Ventura County Community College District

DATE: August 11, 2023
TO: All Bidders
FROM: David Cienfuegos, Interim Purchasing Specialist
SUBJECT: Addendum 1 – Bid 656, Moorpark College Sand Volleyball Project

Attached to this addendum please find updated technical specification drawings and geotechnical report.

E300

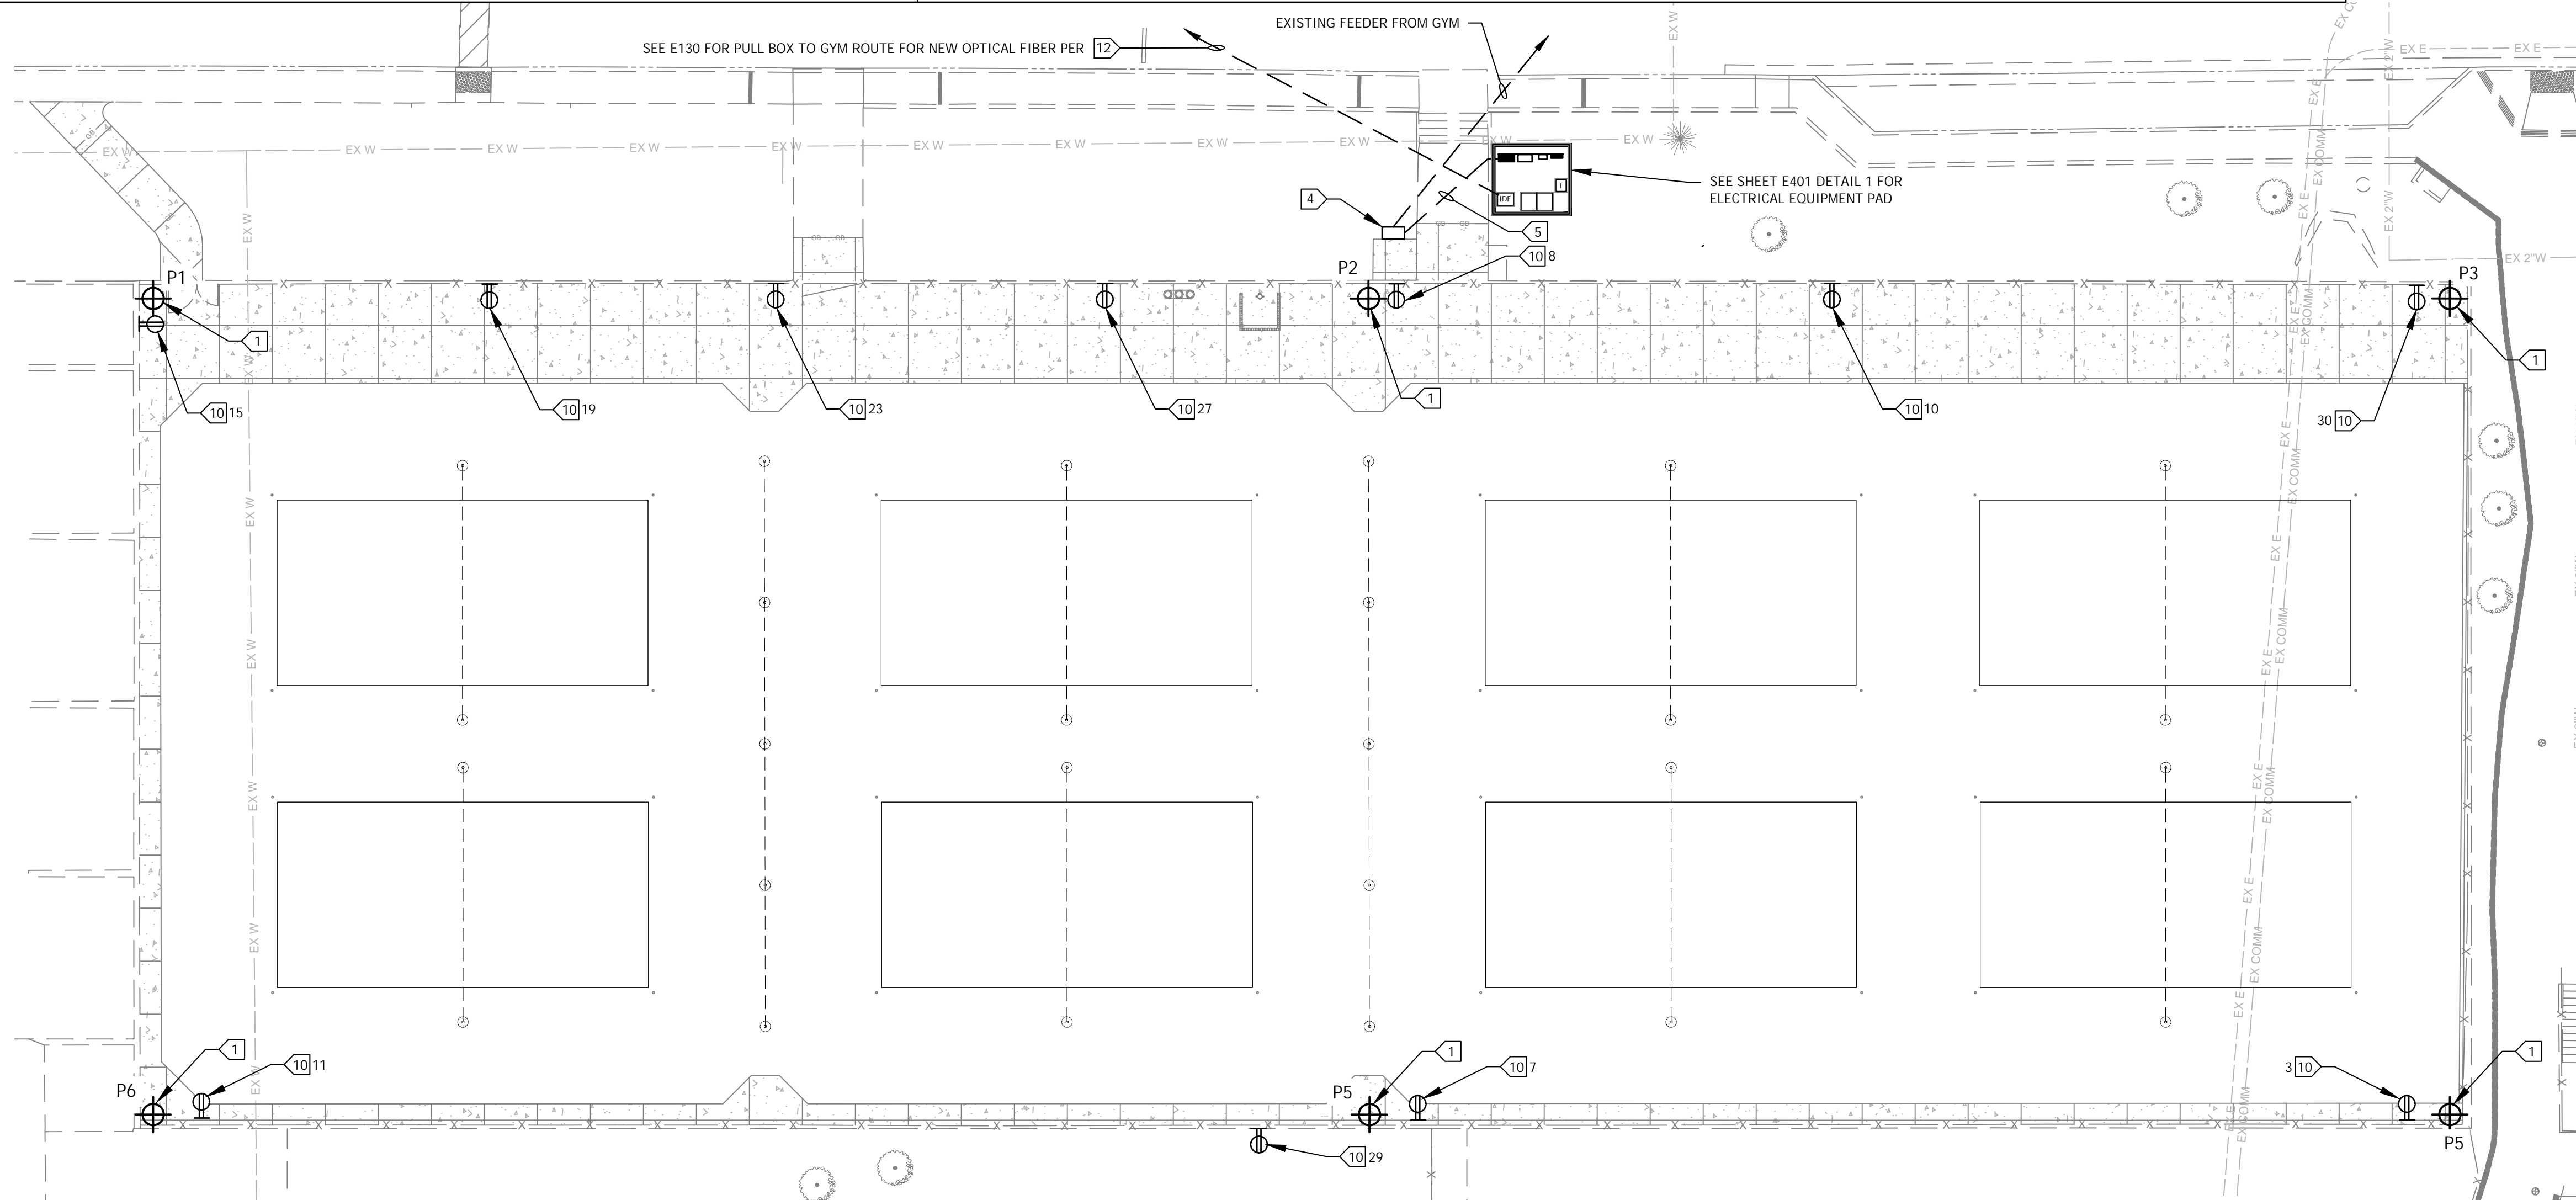
- a. Drinking Fountain to be included under Potable Water.
8. Sheet E300, Key Note 1, states that the 6 Musco Poles are provided by others. Are the other components, like the LSS precast base and fixtures also provided by others? Also, are these components already on campus or are they offsite? And will the contractor be responsible for transporting the poles to the volleyball courts?

9. Is the district purchasing all the Musco gear including light poles and fixtures that the contractor will be installing? Or should the contractor include the purchase price of Musco equipment into their bid price?

- a. Sports lighting is the responsibility of the contractor. All equipment for the light poles, including the other components, LSS precast base, and fixtures, will be provided and installed by the contractor. No components are currently on campus.

- a. The contractor is providing and installing all electrical and lighting gear, including the light pole, gear, and fixtures.
10. Article 6 of the General Conditions states Builder's Risk at 110% of contract value is required, can you confirm if this is needed for this project?
